NOTICE OF ACCEPTANCE (NOA)

DESCRIPTION: Series 122 Aluminum Single Hung Window – S .M .Impact

APPROVAL DOCUMENT: Drawing No. **122-004**, titled " Series 122 Aluminum Single Hung Window-Small Missile Impact", dated 03-10-03 and last revised on 11-07-03, sheets 1 through 4, prepared by manufacturer, signed and sealed by Sifang Zhao, P.E., bearing the Miami-Dade County Product Control Revision stamp with the Notice of Acceptance number and expiration date by the Miami-Dade County Product Control Division. .

Ishaq I. Chanda, P.E.
Product Control Examiner
NOA No 03-1008.04
Expiration Date: August 29, 2008
Approval Date: January 08, 2004

GLAZING DETAIL USING HIGH SILL WITH PARTS #2A & #6A

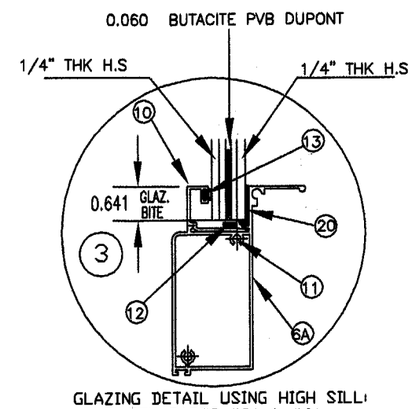
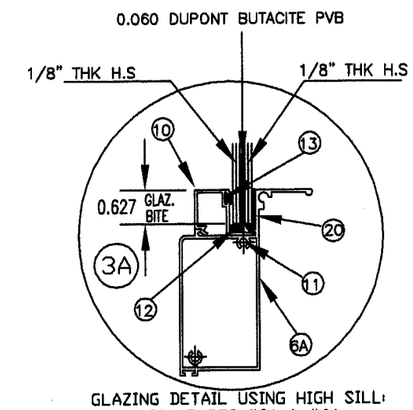
Note: The revision consists of addition of upgrade bottom rail (#6A) & sill (2A).
